1 Review of the Hydrology Section  
2 of the  
3 Streetscape 101  
4 Final Environmental Impact Report (EIR)

5 John J. Helly, PhD

6 July 15, 2018

**Figure 1:** Grand jury recommendations for Leucadia stormwater management [7][9]

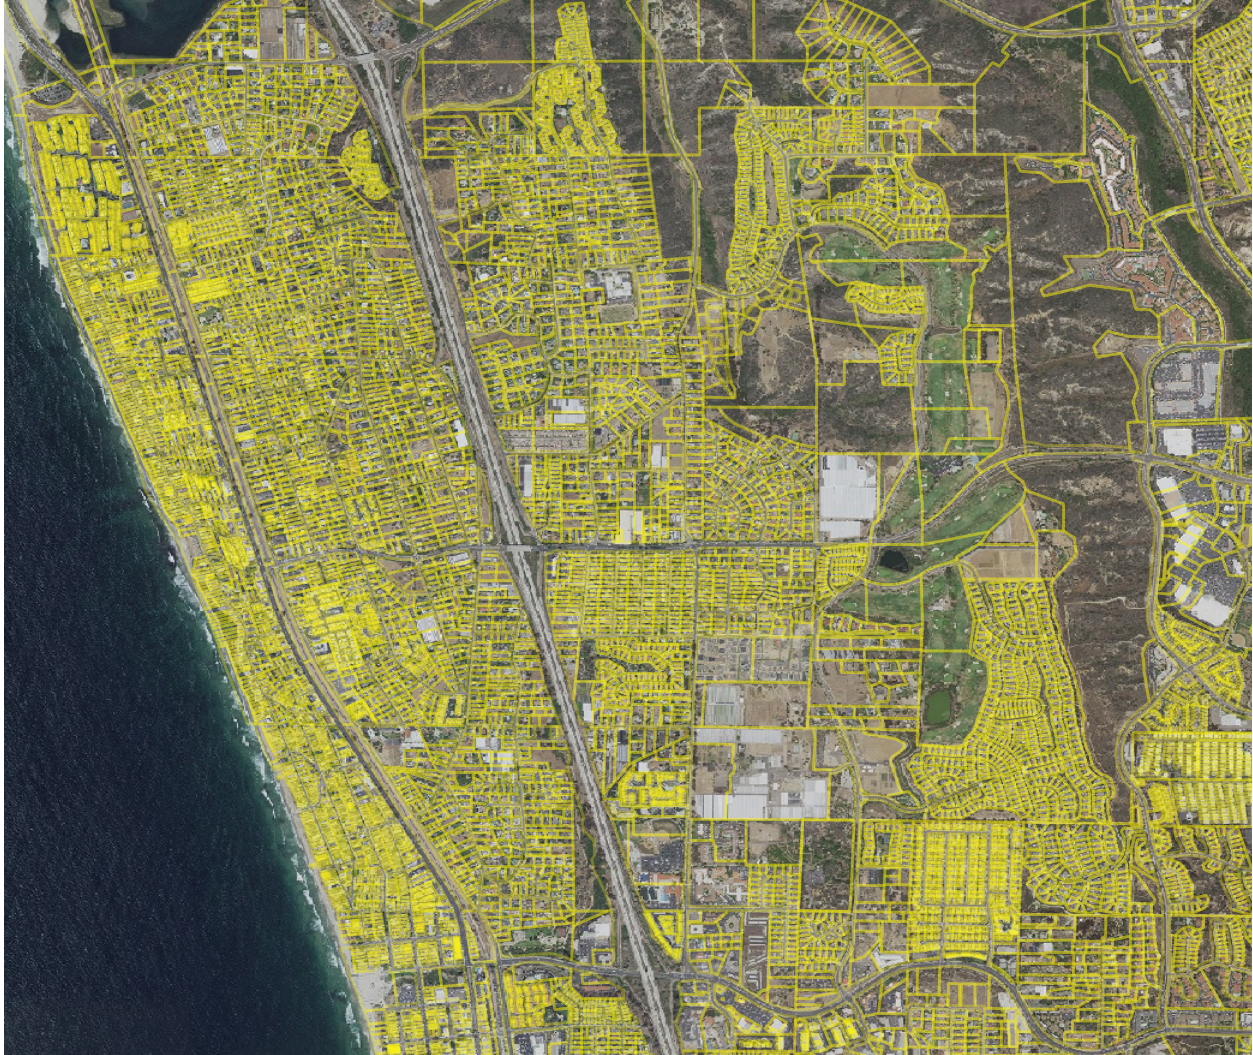
- 36 (I) The long-standing flooding problems, including those subject of a grand jury investigation in the  
37 project area, are completely ignored (Figure 1).  
38 (II) The EIR flatly concludes that all additional sources of wet- and dry- season runoff, and associated  
39 mass loading, introduced by the project, will be mitigated by bioremediation and adherence to existing  
40 BMPs.  
41 (III) The method of analysis used in evaluating the stormwater runoff is inadequate due to both the com-  
42 plexity and size of the project area. Conclusions based on this analysis are specious.

(1) **Prior Relevant Analyses by Grand Jury:** The EIR analysis completely ignores the findings and recommendations (Figure 1) of a Grand Jury investigation of the City of Encinitas with respect to the adequacy of existing storm drain capacity and capability in Leucadia. The proposed project will exacerbate the existing, documented, unmitigated problems there. Additional hard-surfaces will add to existing contaminant loading being pumped to the ocean from this project as well as adding to high-speed runoff that is already overloading an inadequate stormwater system.
